April 18, 2022

Re: Viking Sales and Service – Valhalla Boat Sales – PA 21-04

Pursuant to comments received from staff on December 21, 2021 please accept this letter as a written response. Also included, is the revised plat documents which address the comments where applicable.

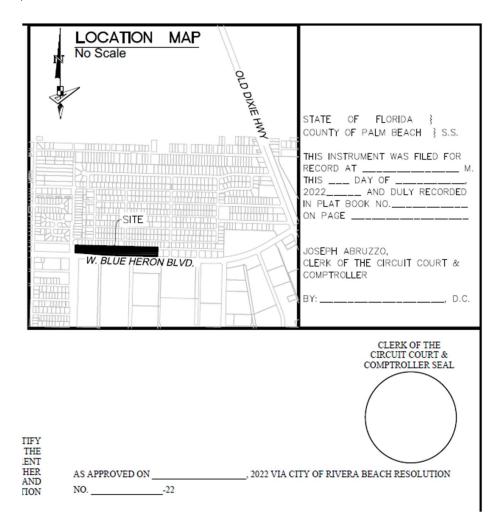
- 7. Please make the revisions to the plat cover page as shown below:
 - a. Add names and PE/SI numbers to the signature circles

Response: Information added to signature circles as requested.

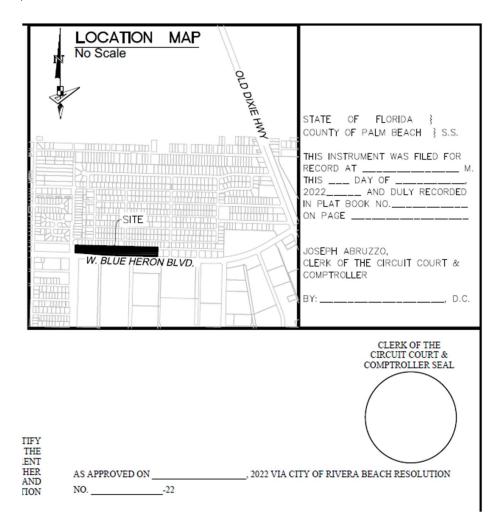
- 7. Please make the revisions to the plat cover page as shown below:
 - a. Add names and PE/SI numbers to the signature circles

Response: Information added to signature circles as requested.

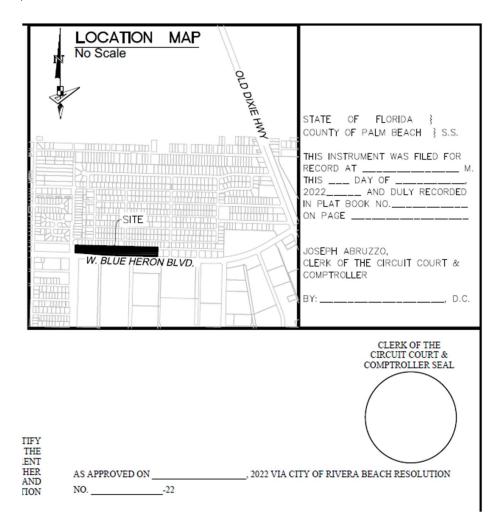
- 7. Please make the revisions to the plat cover page as shown below:
 - a. Add names and PE/SI numbers to the signature circles

Response: Information added to signature circles as requested.

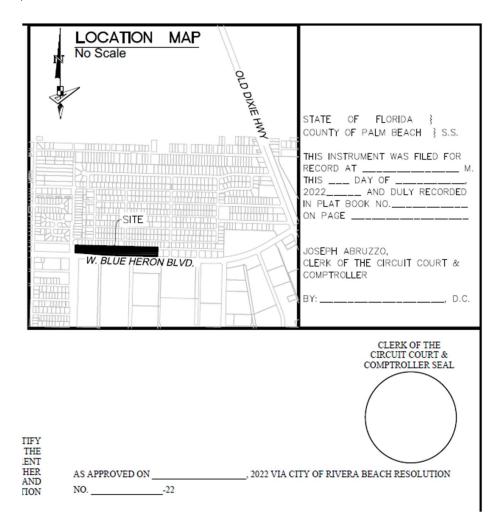
- 7. Please make the revisions to the plat cover page as shown below:
 - a. Add names and PE/SI numbers to the signature circles

Response: Information added to signature circles as requested.

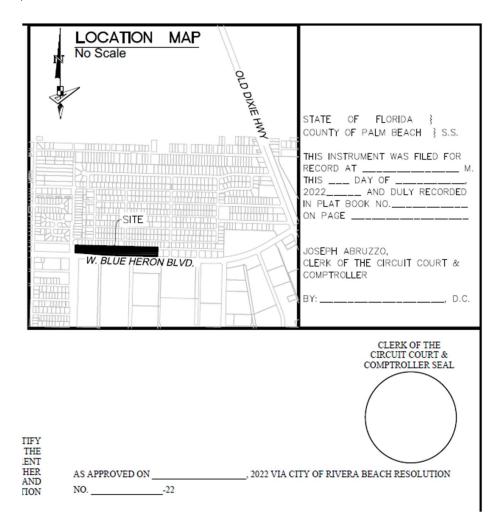
- 7. Please make the revisions to the plat cover page as shown below:
 - a. Add names and PE/SI numbers to the signature circles

Response: Information added to signature circles as requested.

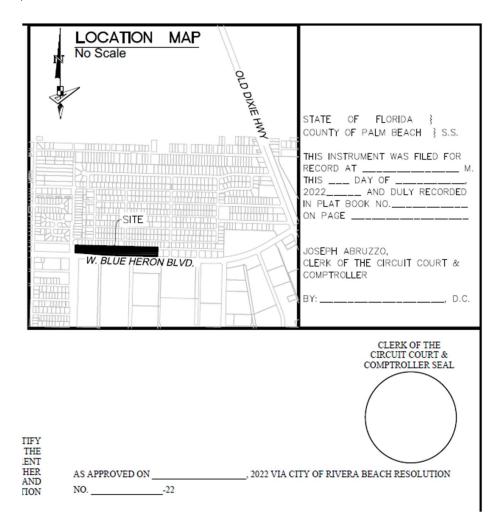
- 7. Please make the revisions to the plat cover page as shown below:
 - a. Add names and PE/SI numbers to the signature circles

Response: Information added to signature circles as requested.

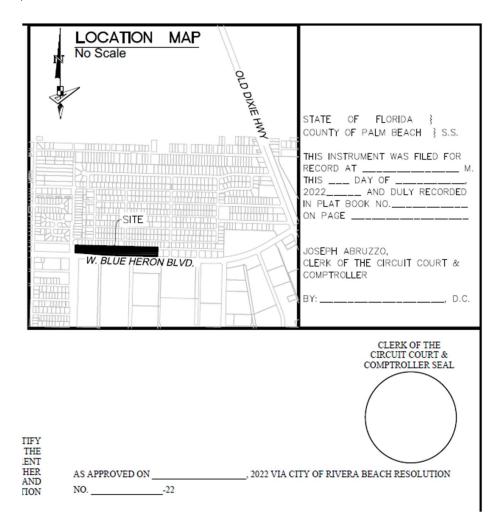
- 7. Please make the revisions to the plat cover page as shown below:
 - a. Add names and PE/SI numbers to the signature circles

Response: Information added to signature circles as requested.
